Our ref: SSD-70316465

Subject: Request for Additional Information

I refer to the Department of Planning, Housing and Infrastructure's (the Department) letter of 13 December 2024, which advised the Department would be providing comments following the exhibition of the Environmental Impact Statement (EIS) for the proposed Burrah Park development (SSD-70316465).

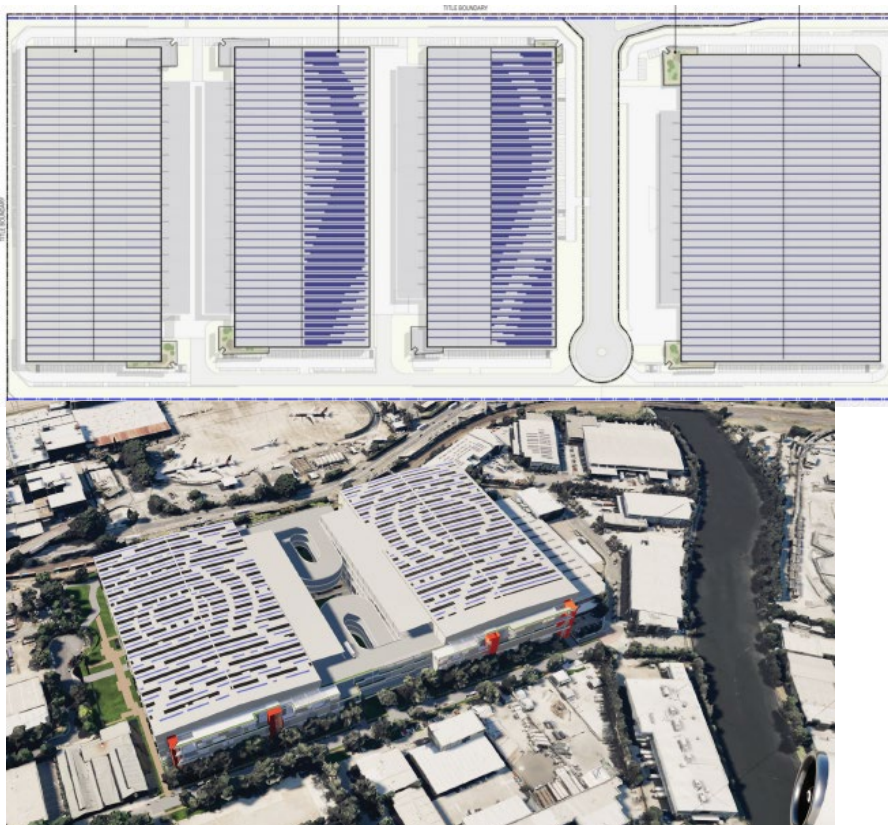
- Clarify responsibility for maintaining the fire access track/active transport link proposed between some lots. The track between Lots 1.1 and 1.2 appears to be located partly across both lots.
